BUILDING ELEVATIONS
1750 OX RESIDENCES - 1750 N OXFORD AVE. - EAU CLAIRE, WI

1750 OX RESIDENCES - 1750 N OXFORD AVE. - EAU CLAIRE, WI

FLOOR PLAN - ROOF

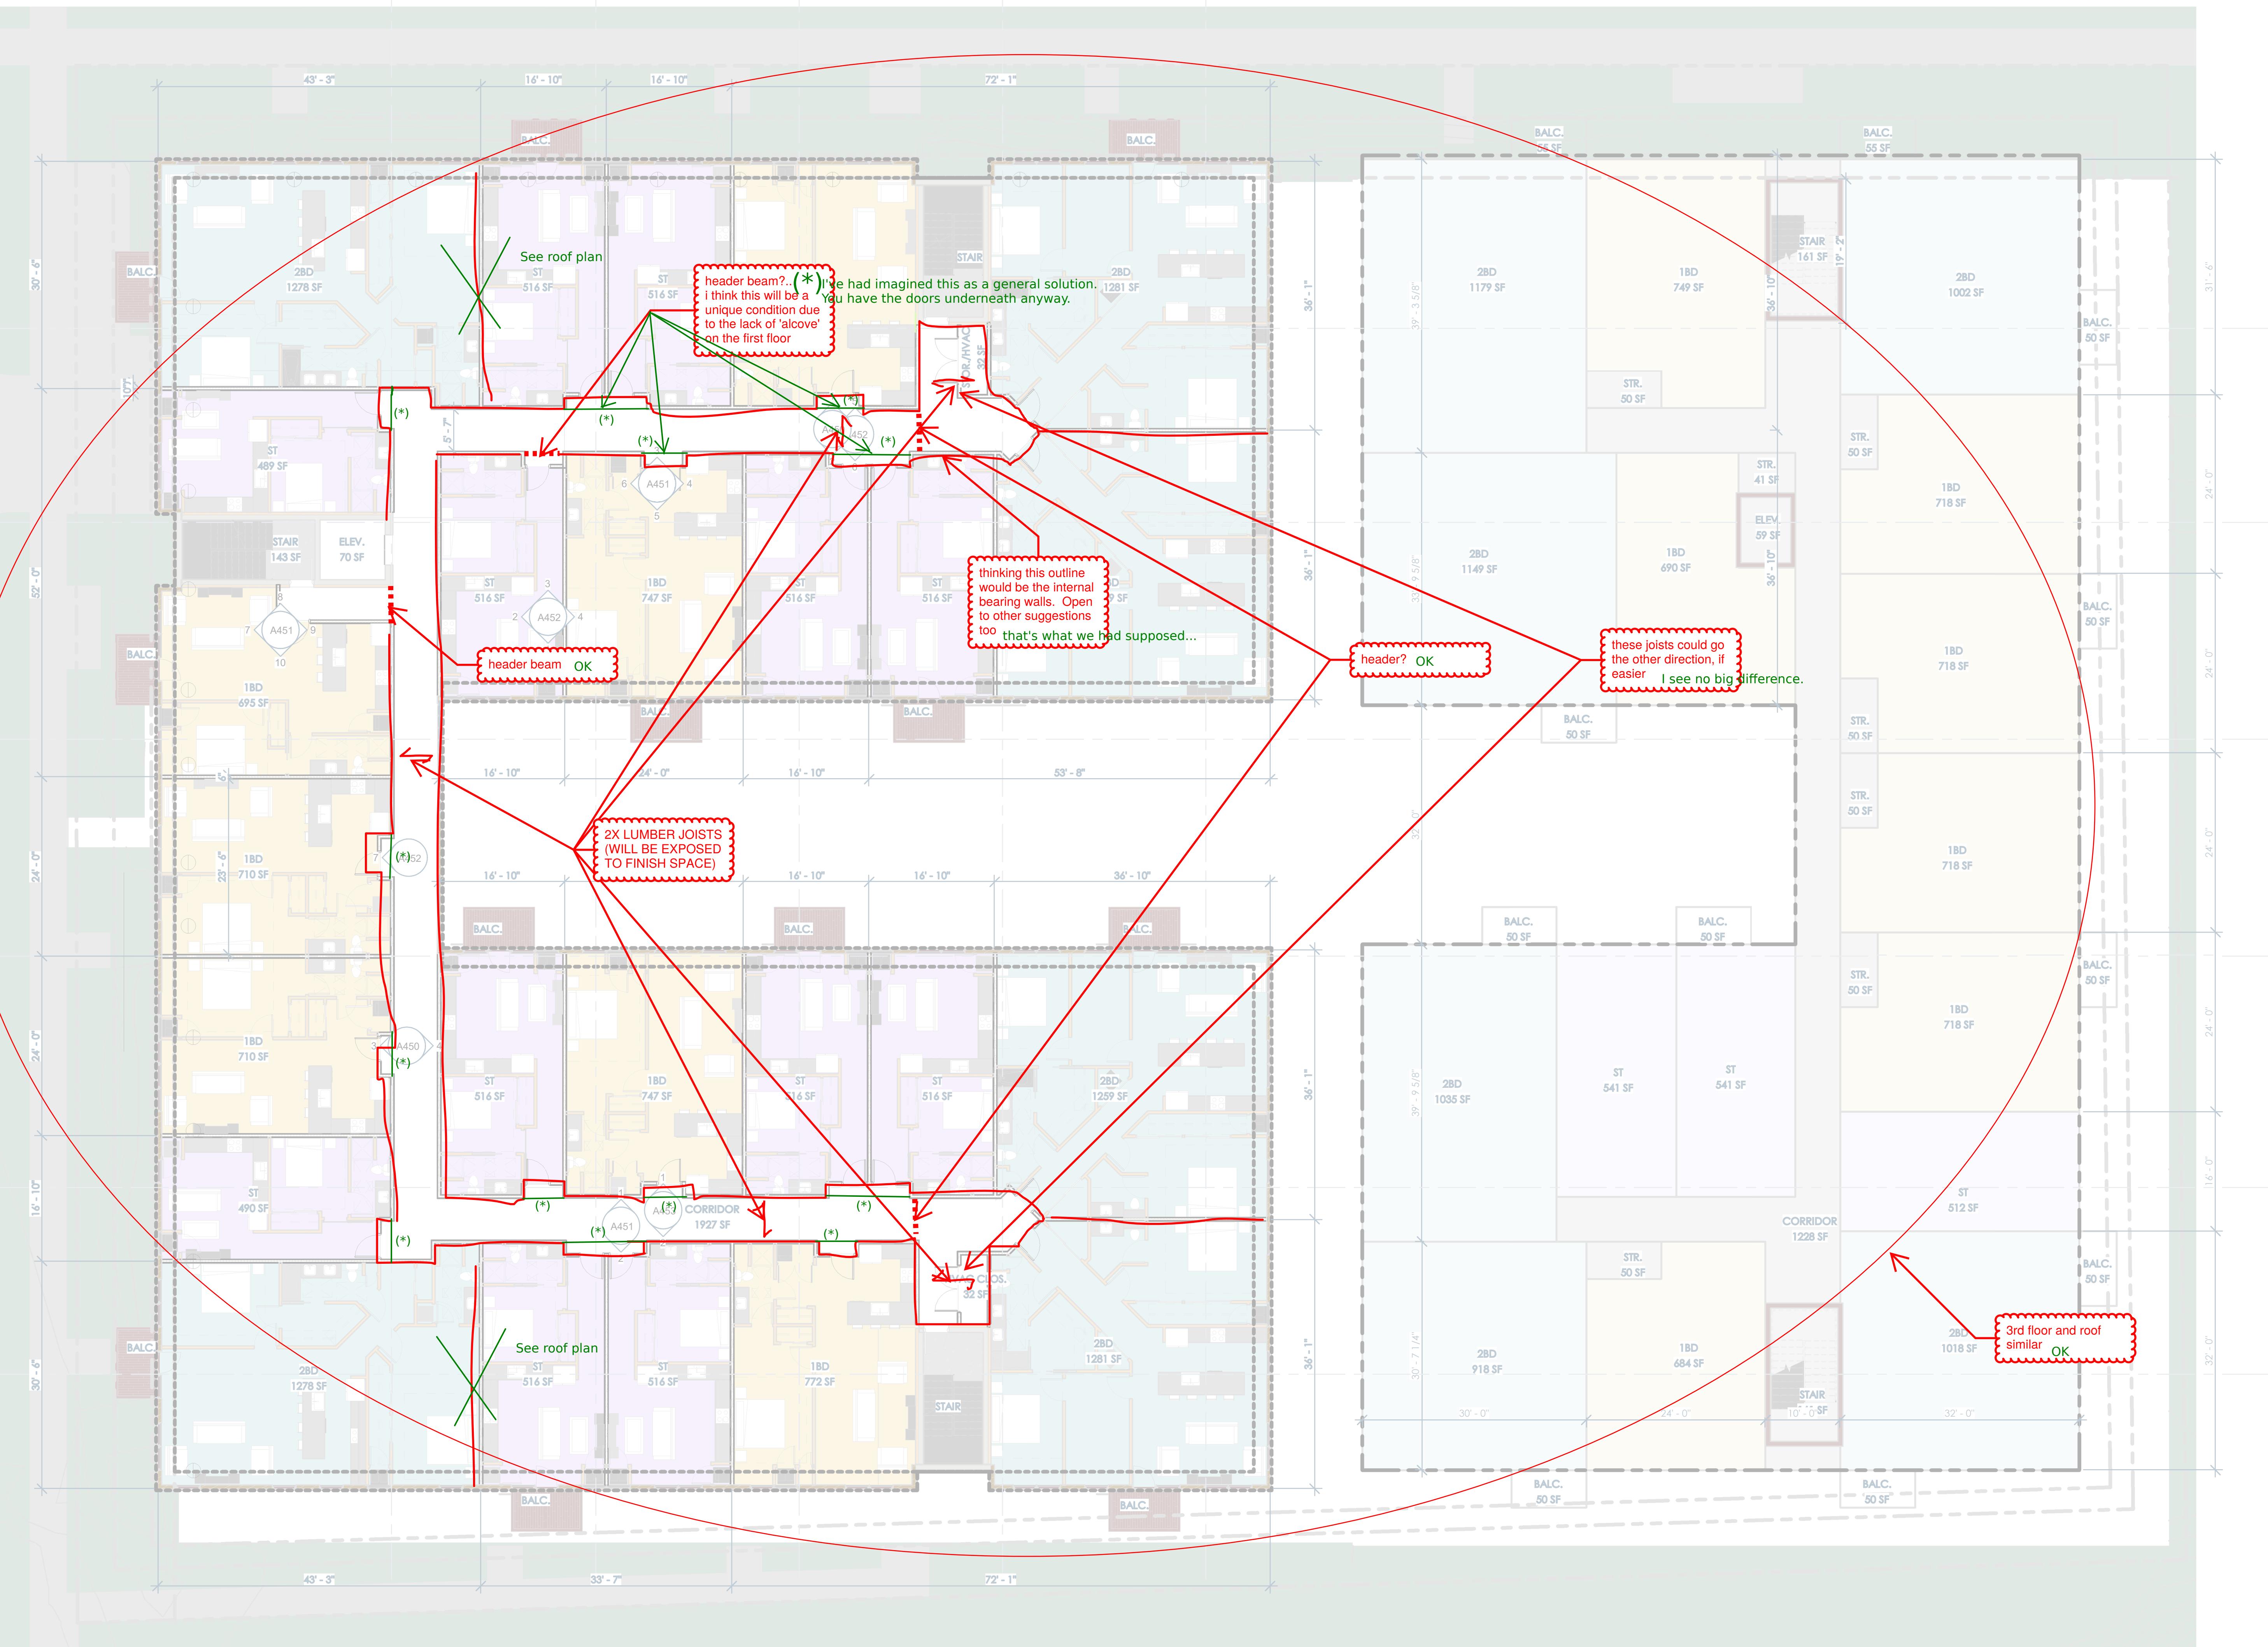
- Red Annotations:**
 - Red X marks indicate prohibited or incorrect configurations at several locations.
 - A large red bracket highlights a section of the roof structure, with the note "header beam OK" and "2X LUMBER JOISTS (WILL BE EXPOSED TO FINISH SPACE) OK".

- Red arrows point to specific locations with the note "header? OK".
 - Red text boxes state "these joists could go the other direction, if easier I see no big difference..."

- Green Annotations:**
 - Green checkmarks indicate correct or preferred configurations.
 - Green arrows point to specific locations.
 - A green bracket highlights a section of the roof structure, with the note "(* See note on 2nd floor)".

- Notes and Labels:**
 - "bearing wall?" is labeled near a vertical wall.
 - "TPO MEMBRANE" is labeled twice on the roof.
 - Callouts with labels A through G point to specific sections of the building's exterior and interior.
